Modifications to Mangoola Coal Mine Plans and Relocation of 500kV Electricity Transmission Line

RESPONSE TO SUBMISSIONS

Prepared by
Umwelt (Australia) Pty Limited
on behalf of
Xstrata Mangoola Pty Limited
and
TransGrid

Project Director:	Barbara Crossley	
Project Manager:	Kate Kelleher	
Report No.	2497/R20/V3	Date: September 2011

FIGURE 2.1

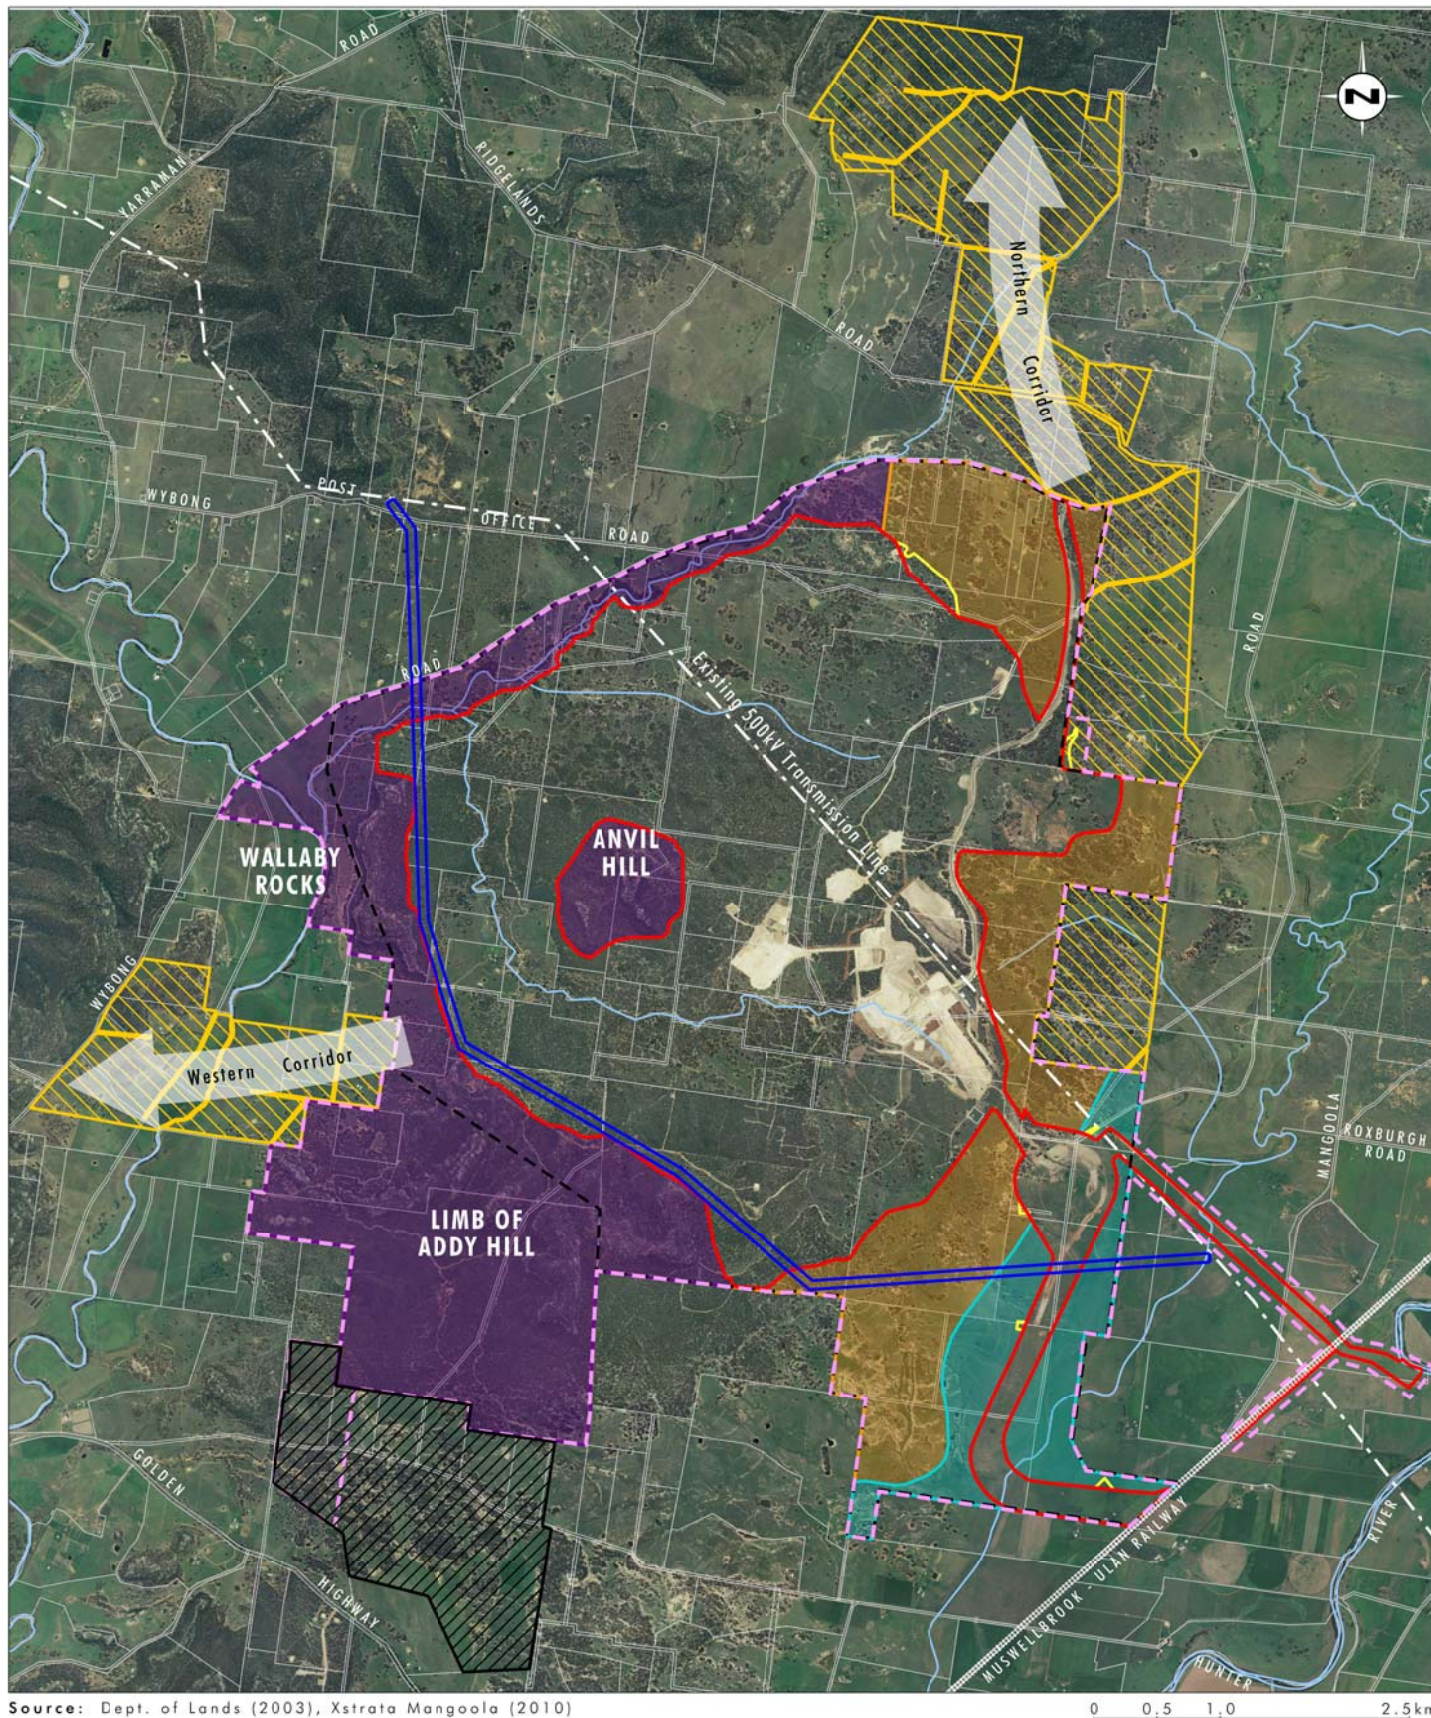
- (a) The mine is positioned in a critical part of the Shire's environmental (woodland connectivity and remnant woodland) corridor. Particularly, the mine will disturb land of significant ecological value and unquestionably some of the most intact local habitats outside of the Shire's national parks and state reserves;**
- (b) The Proponent seeks to remove a significant residual north south corridor (the existing ETL easement) as part of its Application;**

- (a)** It is important to note that the Mangoola Coal Mine has been approved and is under construction, which is substantially complete, and that the combination of the ETL relocation and mine plan modifications involves relatively minor additional clearance of vegetation (i.e. a total of 26.6 hectares of vegetation communities) which will be offset by establishment of an additional 64 hectares of Biodiversity Offset Area, building on the extensive Biodiversity Offset Areas established as part of the existing project approval.
- (b)** The purpose of this comment is unclear. The existing ETL easement was assessed as part of the project disturbance area for the current Mangoola Coal Mine approval. In addition, two corridors are to be retained and/or enhanced with the aim of improved habitat connectivity and protection (refer **Figure 2.1**).

FIGURE 3.1

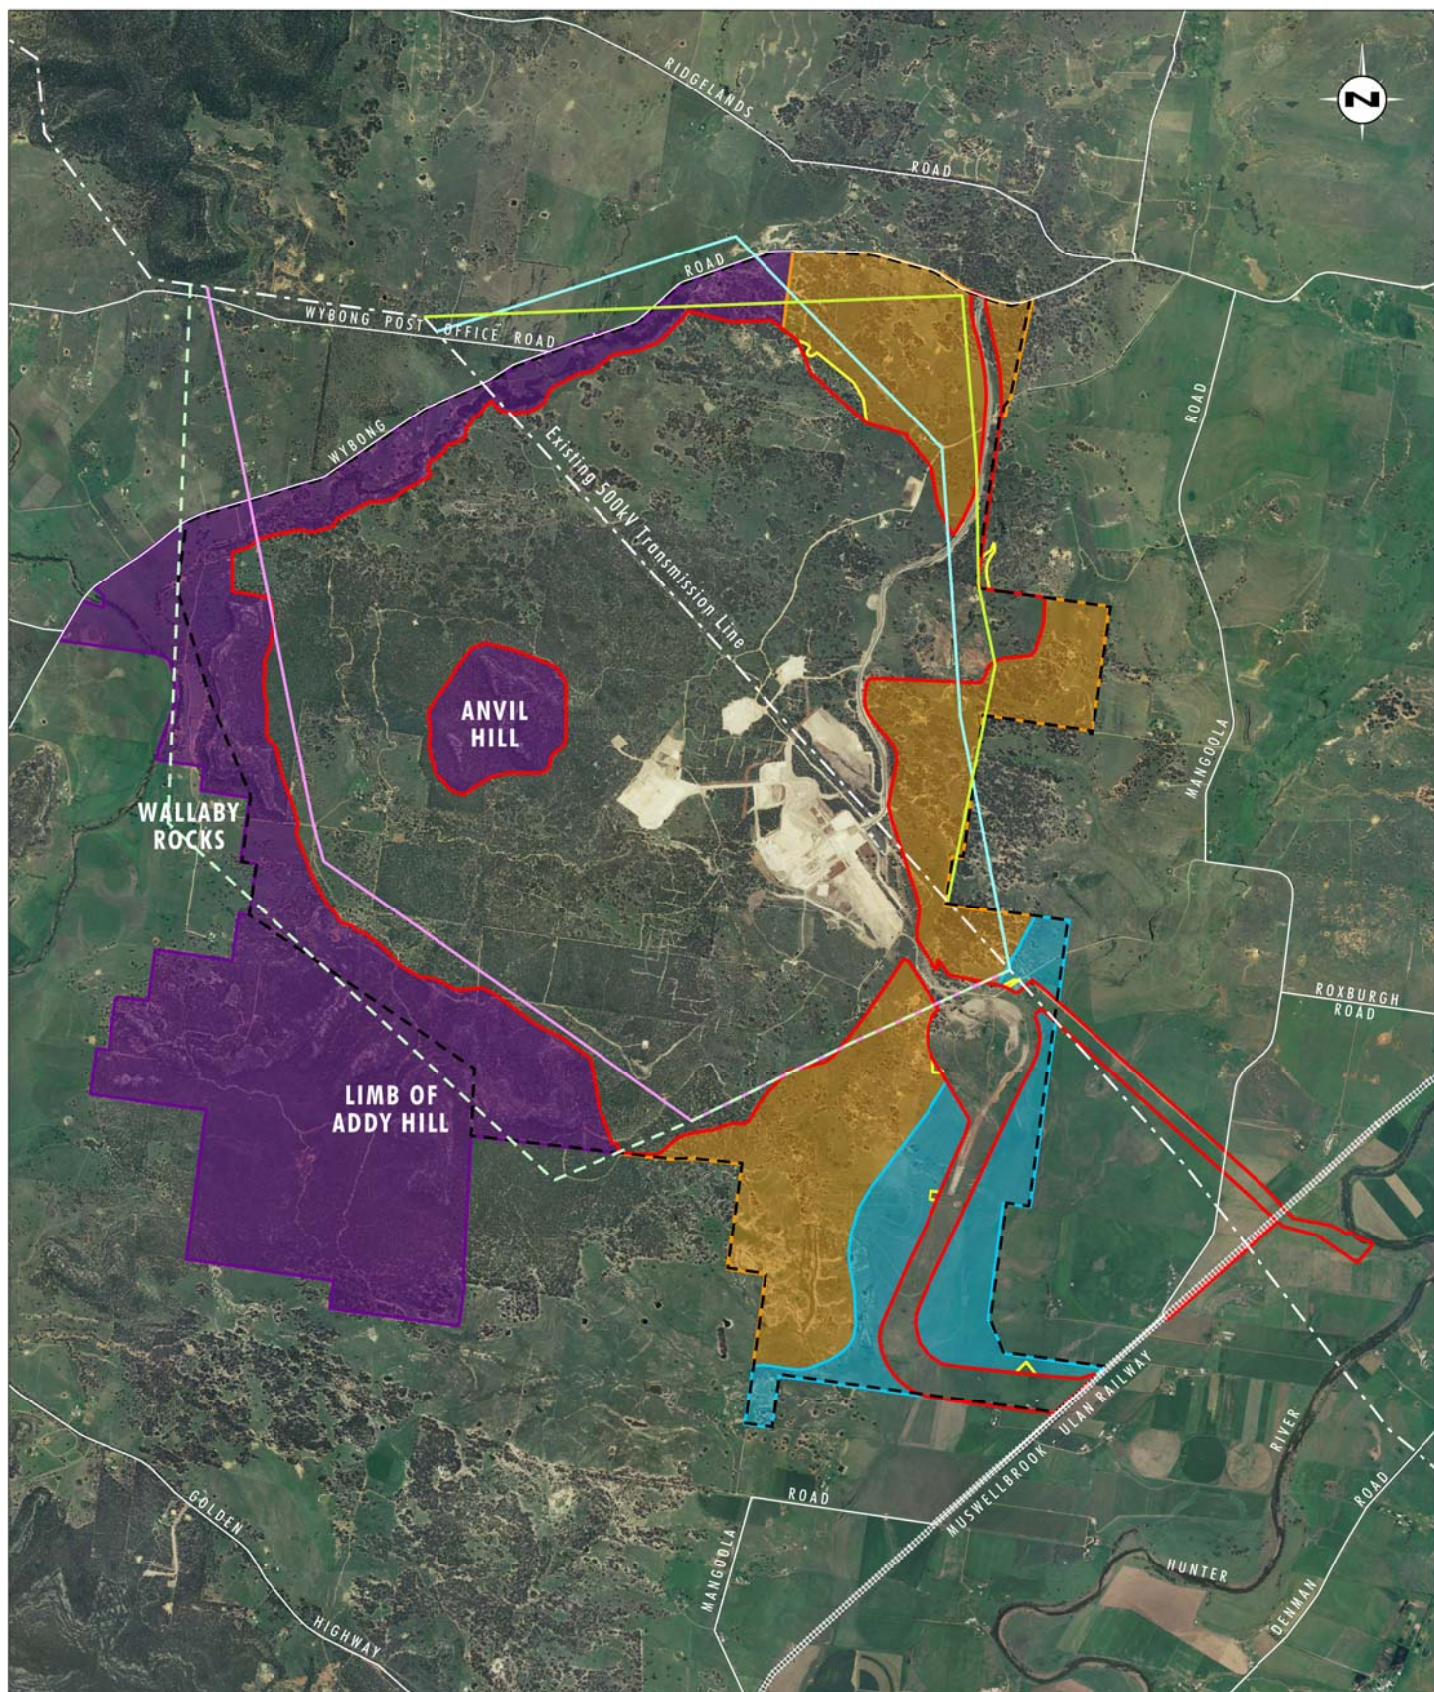
We believe that the route proposed by Xstrata Mangoola Pty Ltd does not provide sufficient protection for the important regional biodiversity functions of this substantially intact corridor from Myambat and Wollemi/Goulbourn River NP to Manobalai NT and the forested Ridglands of the Wybong Valley that are integral to the closure of the Greater Eastern Ranges Initiative in the Hunter Region.

- no relocation of the ETL;
- Option 1 - relocation of the ETL to the north and east of the approved project disturbance area; and
- Option 2 - relocation of the ETL to the west and south, outside of the approved project disturbance area.

Alternative route options are illustrated in **Figure 3.1**.

During the community consultation sessions held for the proposed mine plan modifications and ETL relocation, the WAG also proposed a version of the north and east route as an alternative. Mangoola Coal provided a specific written response to WAG on 14 August 2009 (refer to **Appendix 4**) in relation to their proposed route for the 500 kV ETL which Mangoola Coal considers to not be a feasible option. The option is not considered feasible for the same reasons that the north and east route was not preferred, i.e.:

- it traverses considerable areas of the approved Conservation Offset Area (which has been established as an offset for both Aboriginal cultural heritage and ecological values) and habitat enhancement areas;

FIGURE 3.2

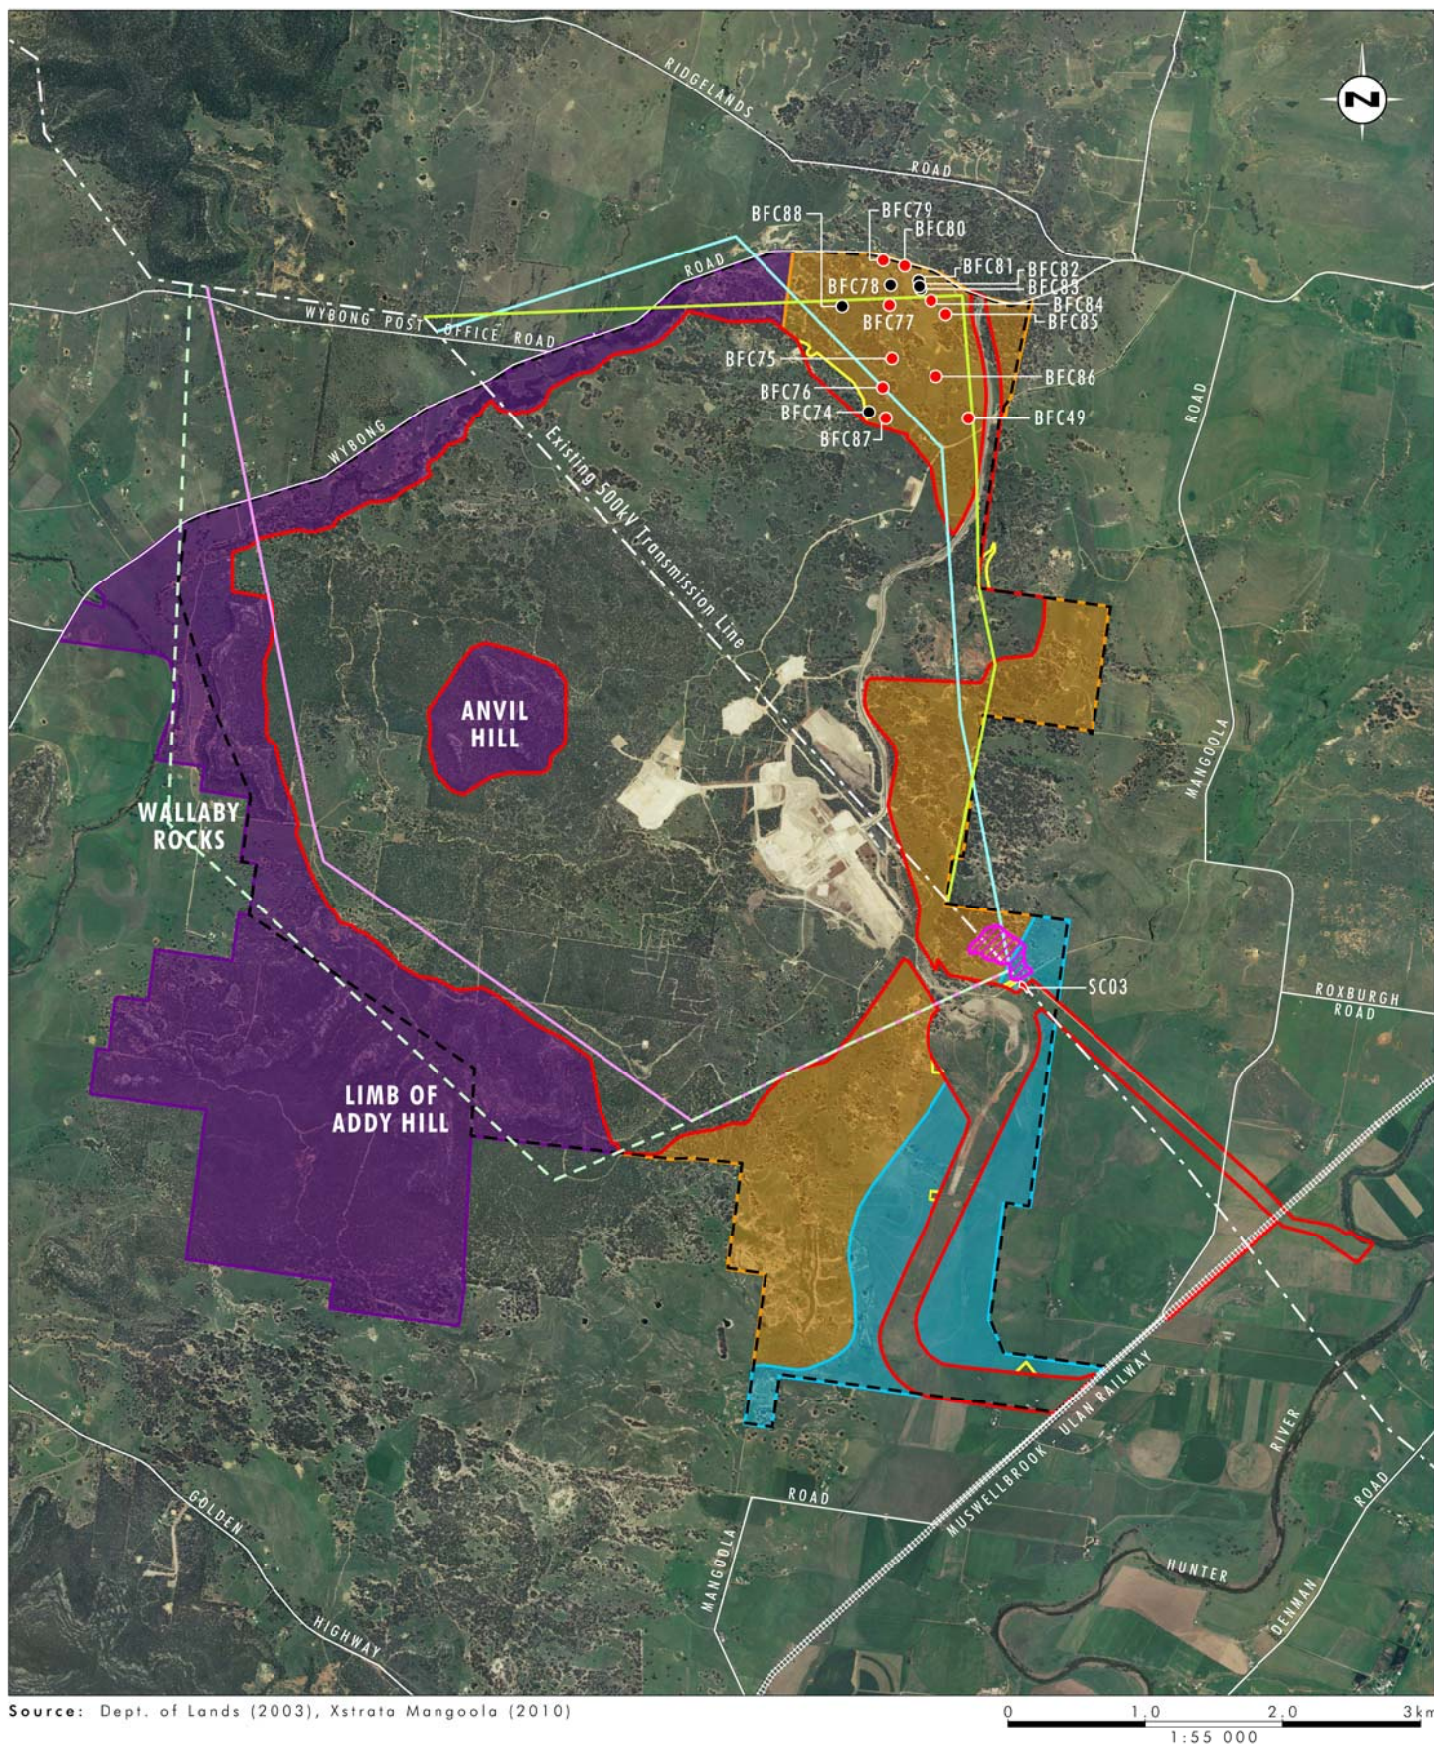
Such an open-ended commitment belies approval particularly as Xstrata Mangoola have not complied with consent conditions themselves and have sought by progressive modification applications and stealth to avoid comprehensive review of their intention to supplant the original mine plan, expert panel review and consent with a radically different mine plan. Clearly (see fig 5.26) the western ETL Route is a far greater interference, steriliser and potential destroyer of Aboriginal Heritage than either the existing or NE ETL Routes, recognising that the NE Route as shown is capable of slight modification to remove impact on SC10.

In comparison, the WAG proposed ETL alignment impacts a length of almost 3 kilometres within the Big Flat Creek ACHOA in an area containing a number of recorded archaeological sites. It is assumed it would not be possible to span a 3 kilometre length at the proposed angle and therefore this would require the establishment of a new tower or towers within the Big Flat Creek ACHOA, thereby resulting in a higher level of impact to the Aboriginal cultural heritage values of this area and potentially requiring a greater level of harm to Aboriginal objects. **Figure 3.2** illustrates the location of isolated finds and archaeological artefact scatters within the Big Flat Creek ACHOA, offset areas, the proposed WAG ETL alignment and the preferred option.

Mangoola Coal has identified to Registered Aboriginal Parties that there is potential for a land offset available to the west of Wallaby Rocks; the process of consultation is continuing and the majority of the Registered Aboriginal Parties have indicated that they wish to inspect the area to consider its Aboriginal cultural values. This inspection will be arranged as part of upcoming cultural heritage work at Mangoola Coal Mine and the outcomes reported to DP&I and the OEH.

FIGURE 3.3

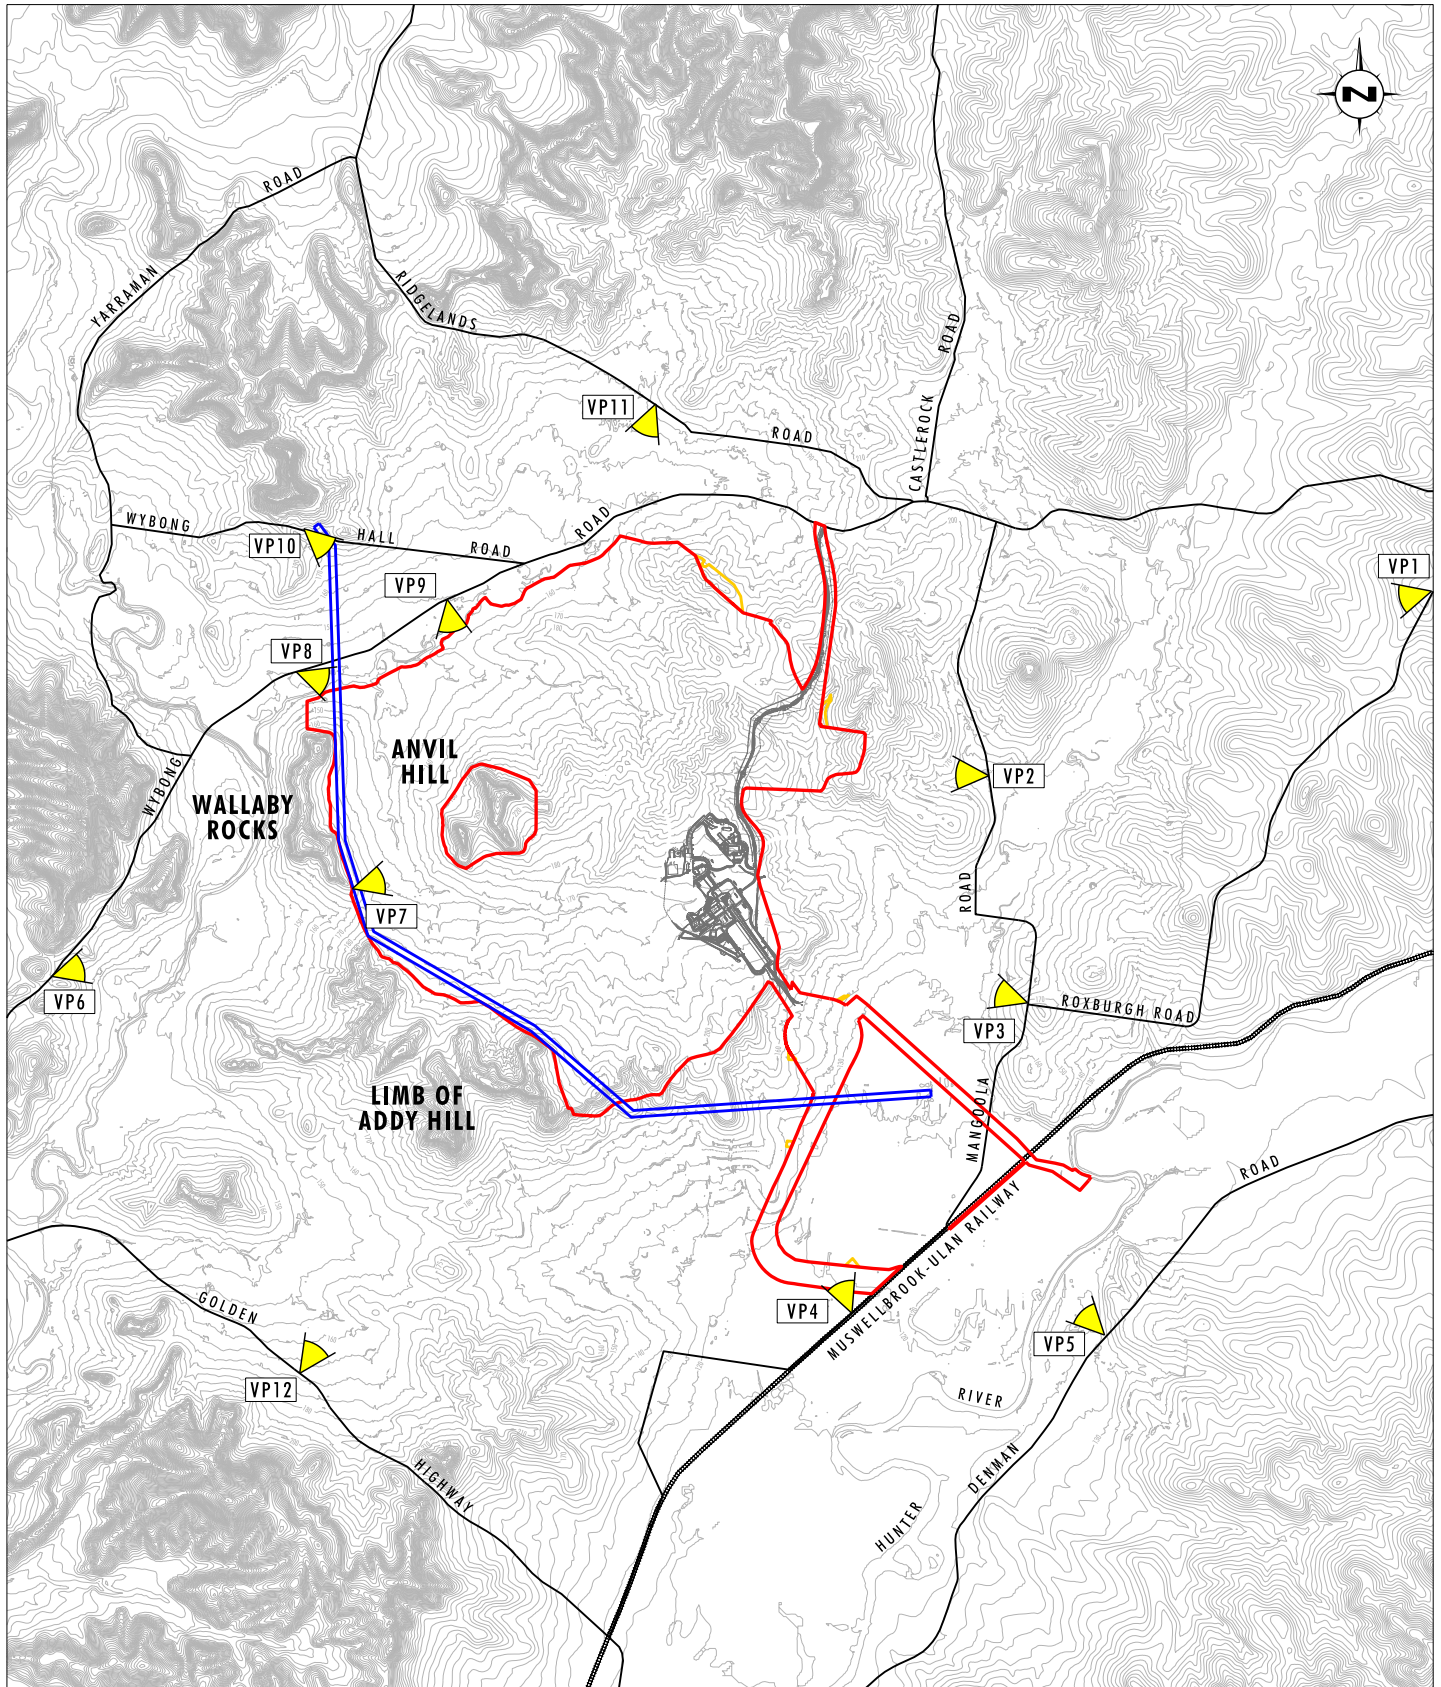
The partially relocated route selected by Xstrata is also the most visually obtrusive route (by a large factor) of the two major competing options i.e. NE or SW.

The assessment concluded that the visual impacts of the passage of the ETL relocation through the offset areas are of no greater significance than the impacts currently arising from the existing ETL where it traverses the Big Flat Creek Conservation Area, when considered from the adjacent viewpoints to each area (refer **Figure 3.3**). The visual impact of the easement clearing through the Conservation Offset Area will be evident at a time when the area becomes more heavily vegetated and the difference between the Conservation Area
